Proposal for Changes to NEXT / FEXT Mask

John D'Ambrosia
Tyco Electronics

MDNEXT Proposed Limit

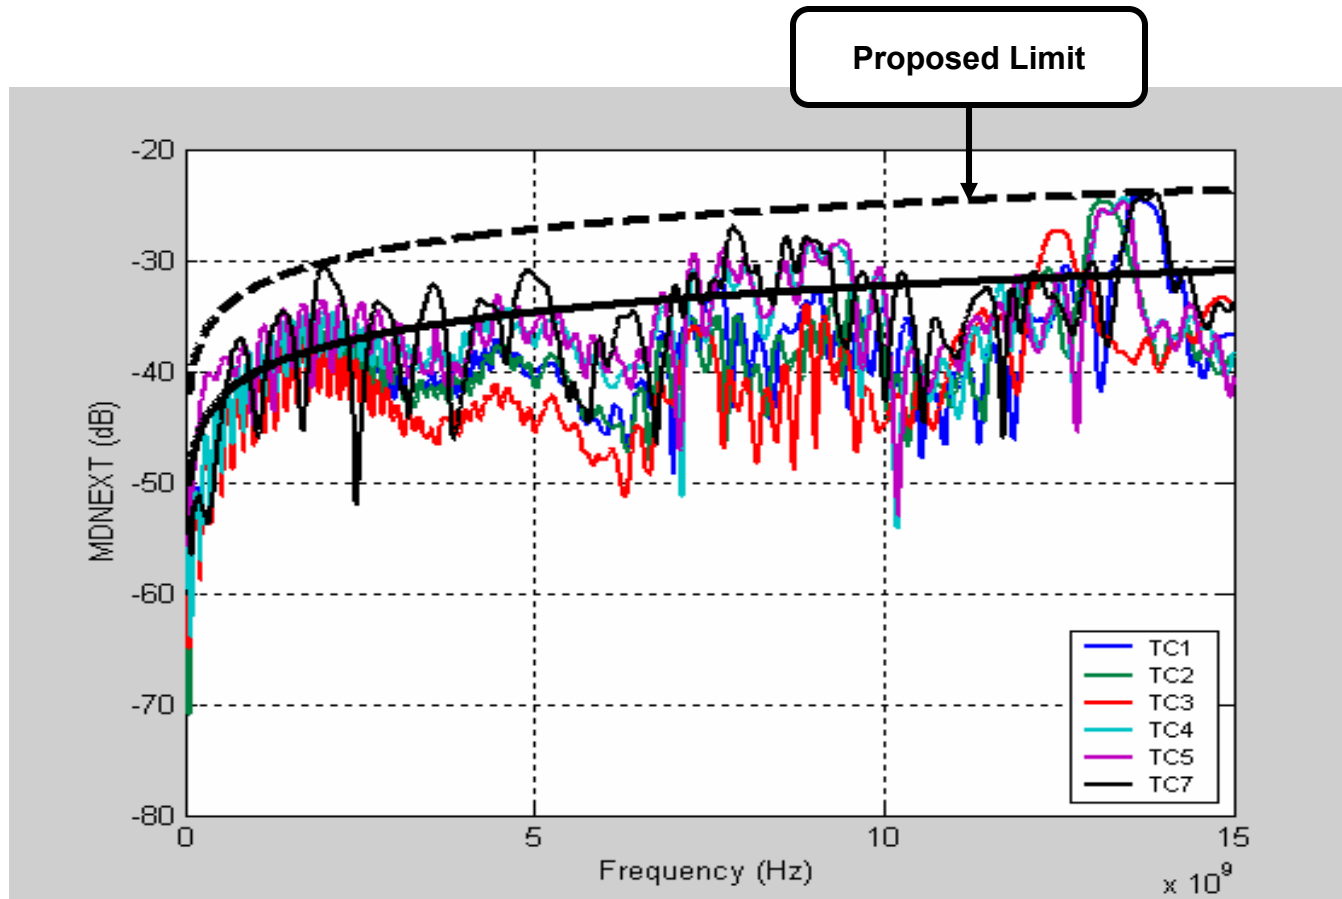
$$MDNEXT(dB) \leq -25 + 7.5 \log_{10} \left(\frac{f}{10GHz} \right), f = 0.1 \dots 15GHz$$

MDFEXT Proposed Limit

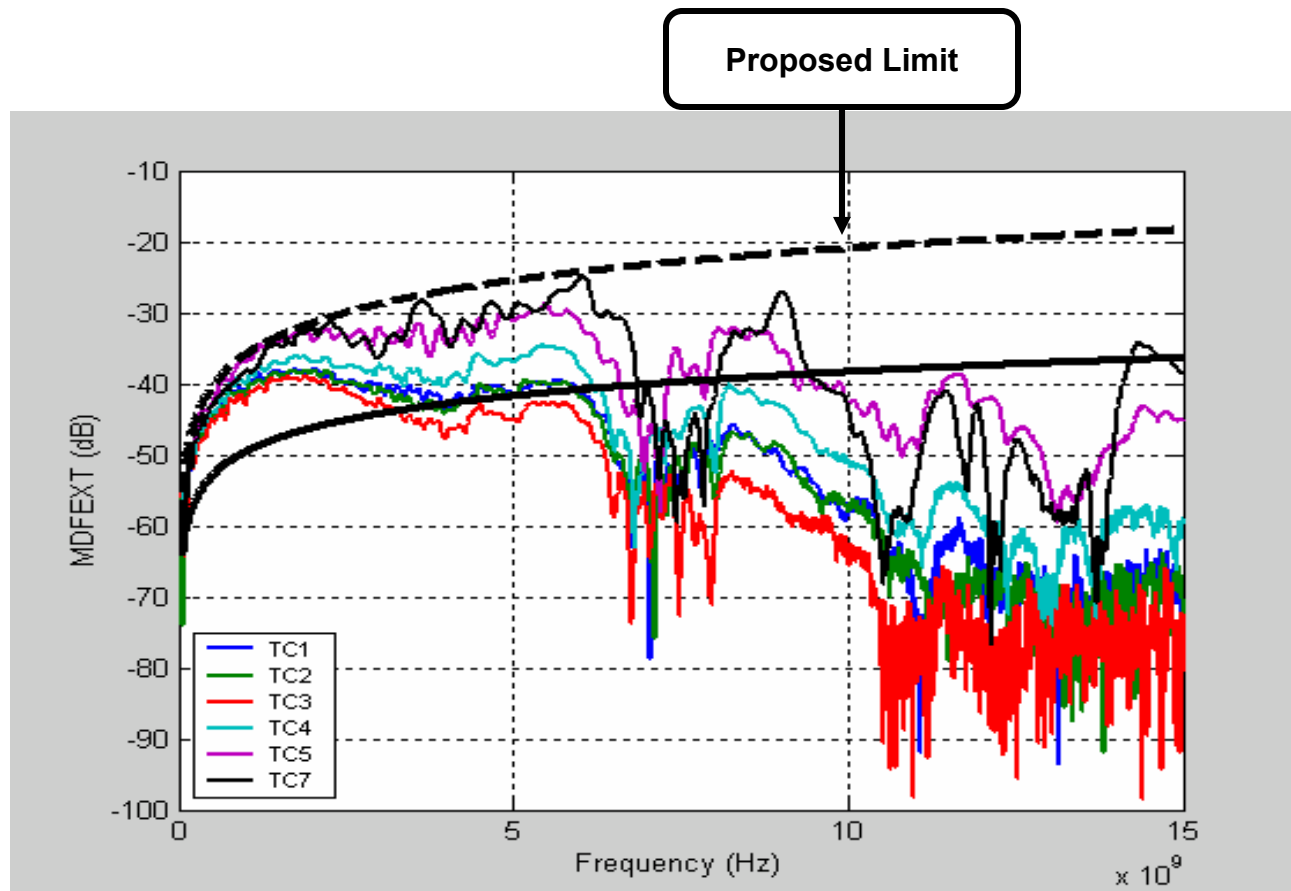
$$MDFEXT(dB) \leq -21 + 15 \log_{10} \left(\frac{f}{10GHz} \right), f = 0.1 \dots 15GHz$$

Unintentional SNR Squeeze

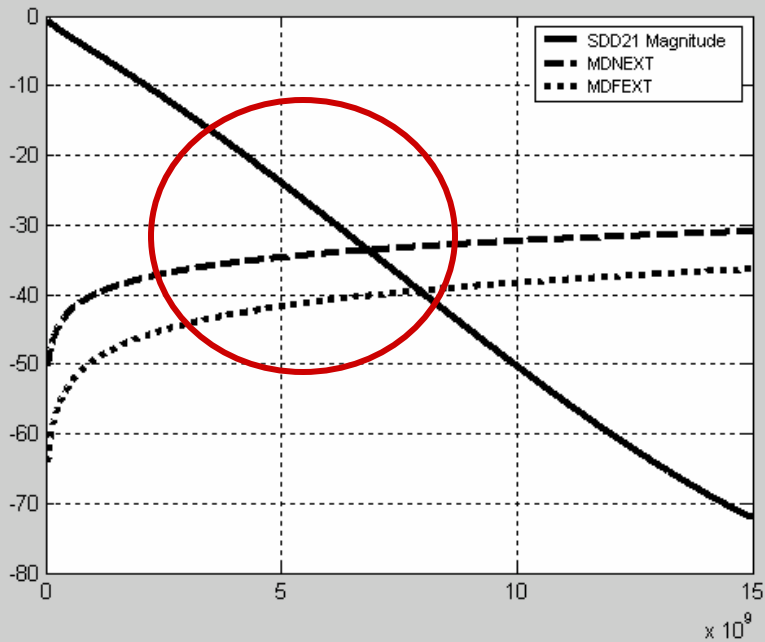
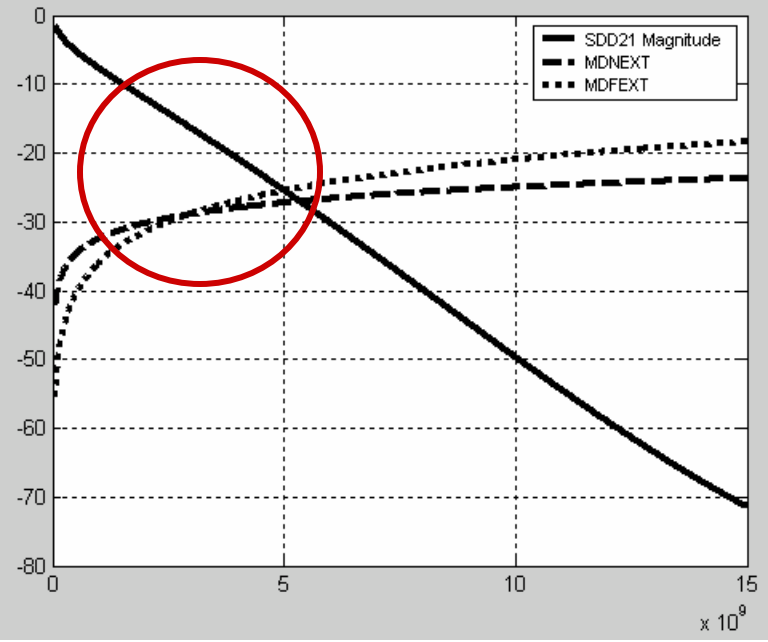
Original "Stake in the Ground"

Subsequent Modifications
(proposed)
